RUSSIAN MARITIME REGISTER OF SHIPPING

CIRCULAR LETTER

No.312-16-1463c

amendments to the Rules for the Classification and Construction of Inland Navigation Ships (for the European Inland Waterways), 2017, ND No. 2-020101-102-E

Fig. 3.1.12.13".

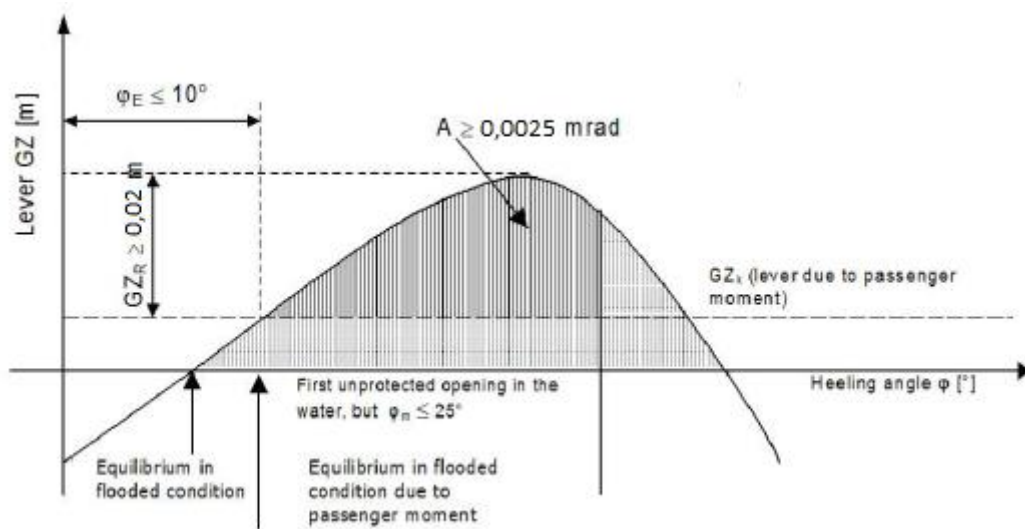
57 Existing Fig. 3.1.14.13 is replaced by the following:
